Memorandum

From: Kris Kirby, Superintendent, Manhattan Project National Historical Park

Subject: NPS Scoping Comments on Kairos Test Reactor

K-25 Area Oak Ridge Developments

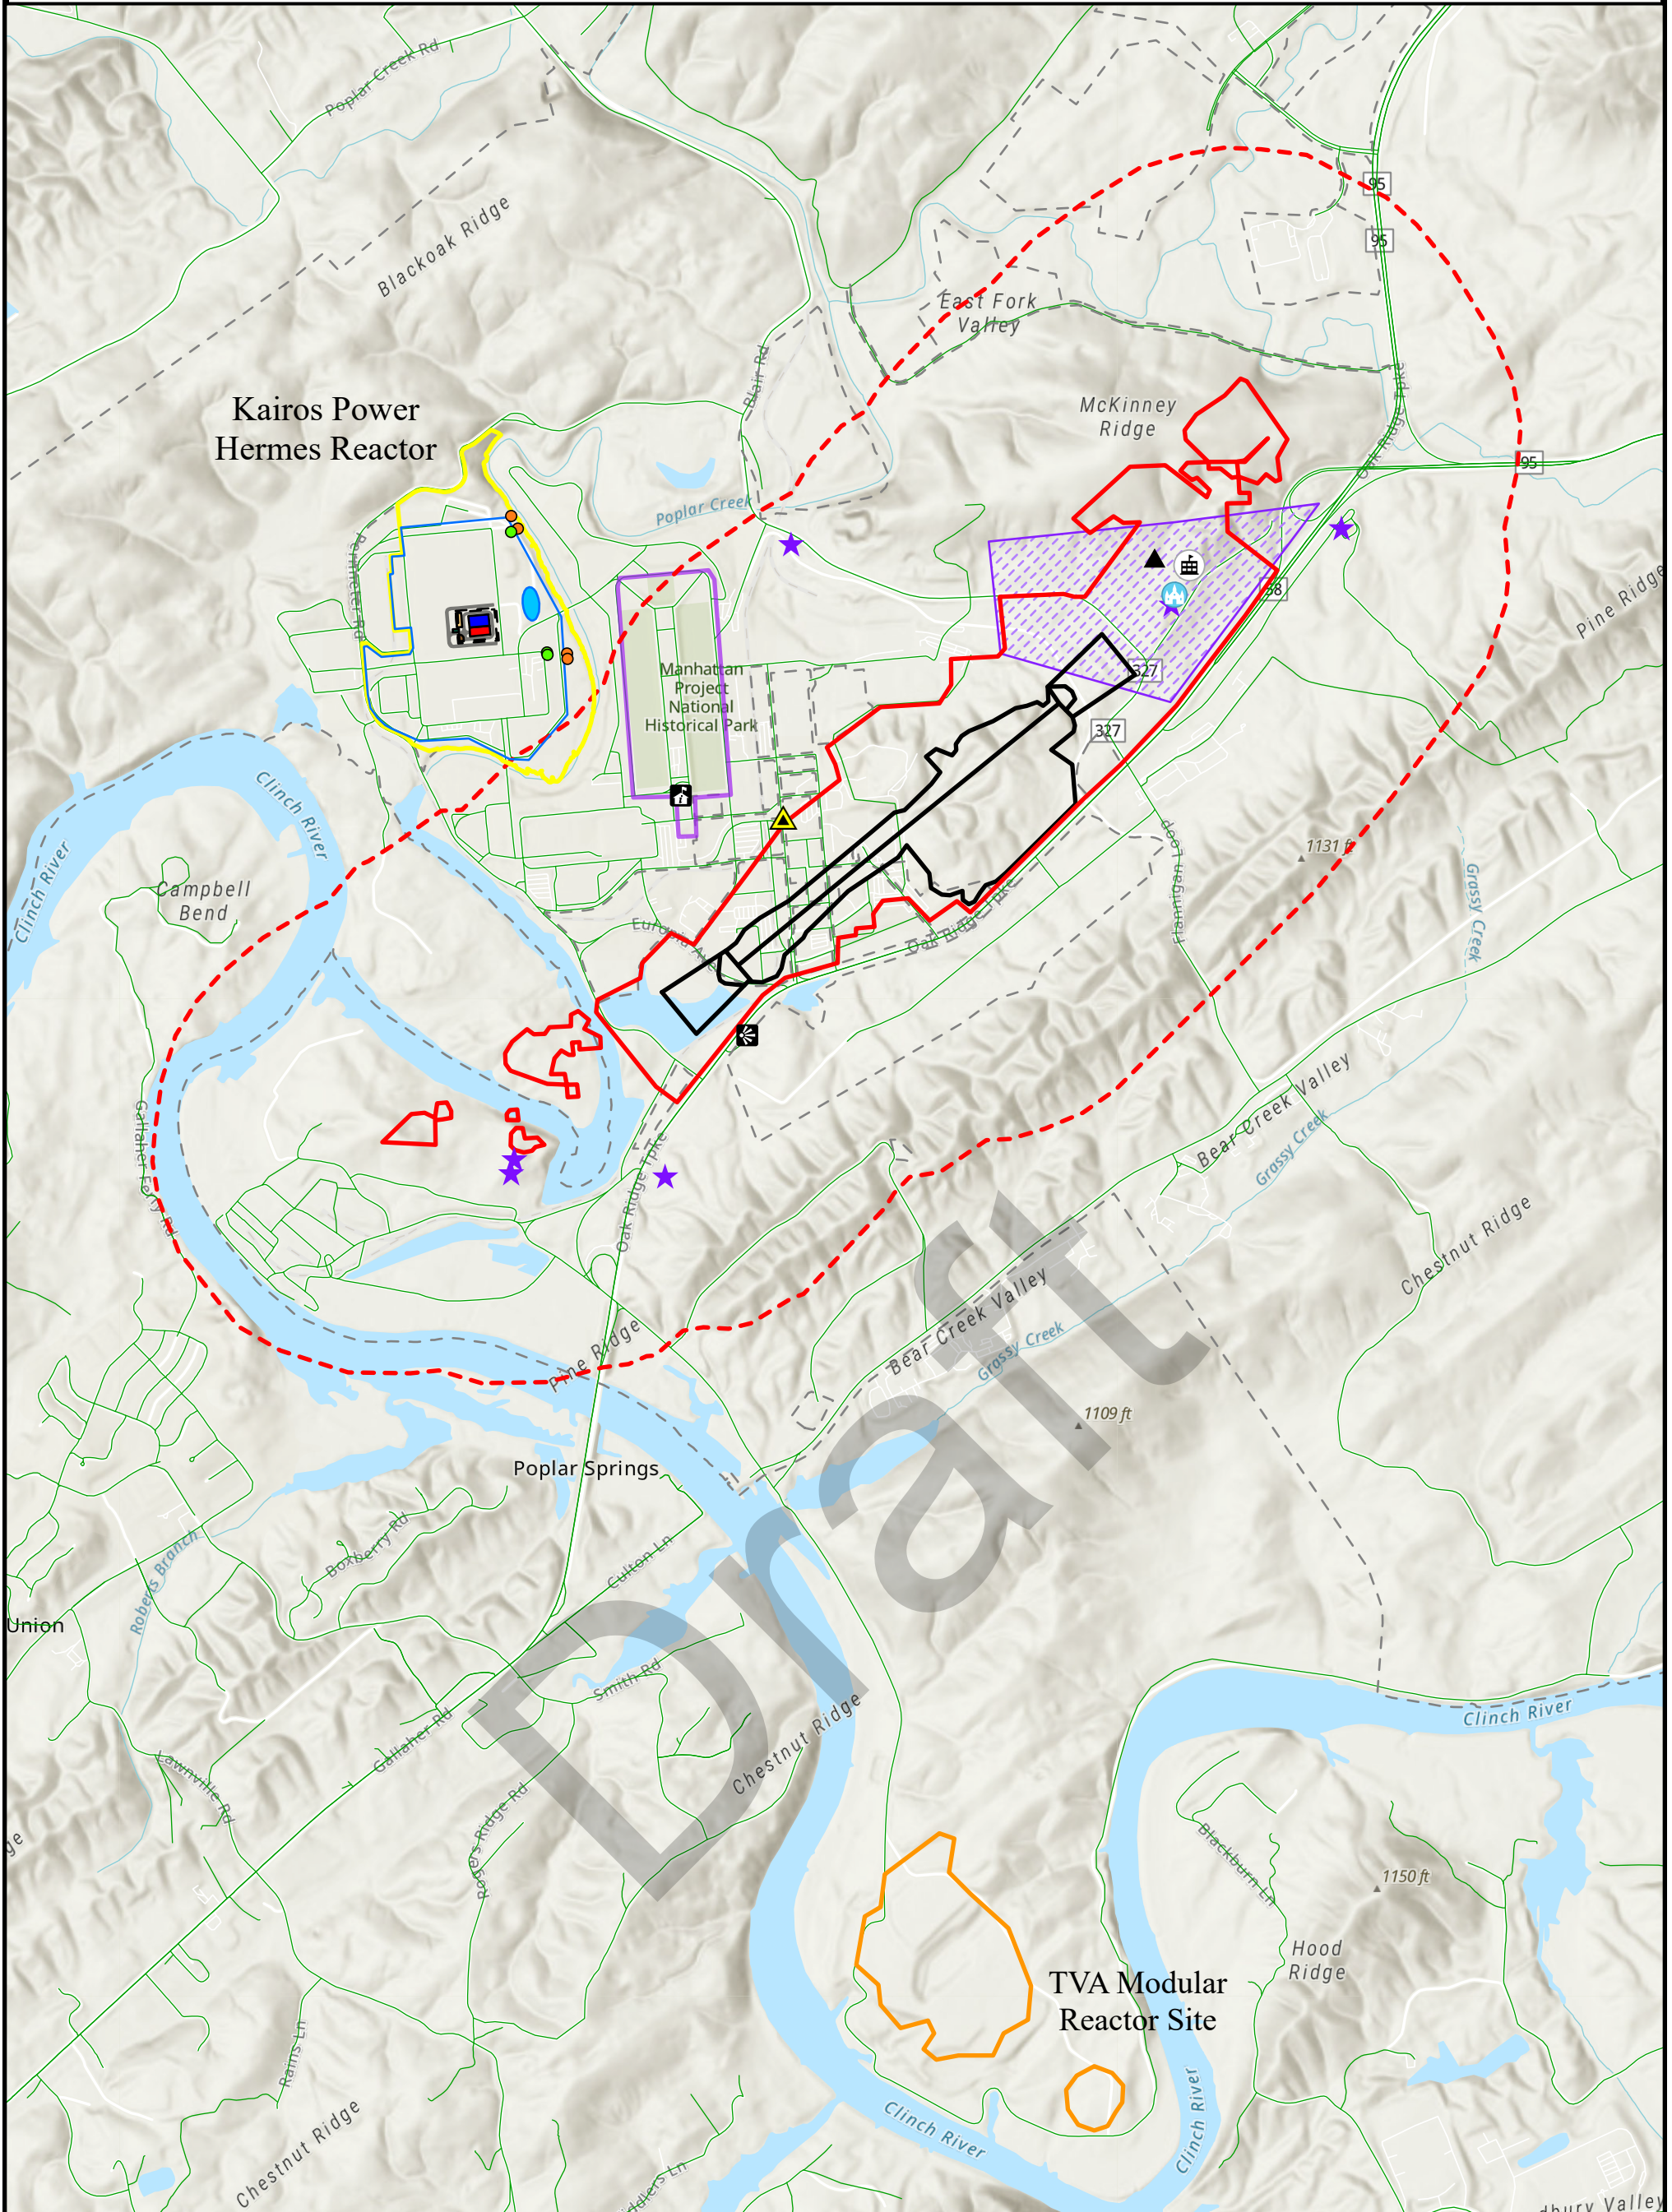
- DOE is still in the process of developing plans in the area, and public access locations to the K-25 NPS site have not yet been determined. At this point, it is uncertain how close the public will be able to get to the Kairos facility. Adding to the uncertainty is the

planned nearby Oak Ridge airport, which has the possibility of impacting public access to the NPS site and other planned developments. We are monitoring these developments and will take them into consideration in relationship to the Kairos project when planning for public access at the K-25 site.
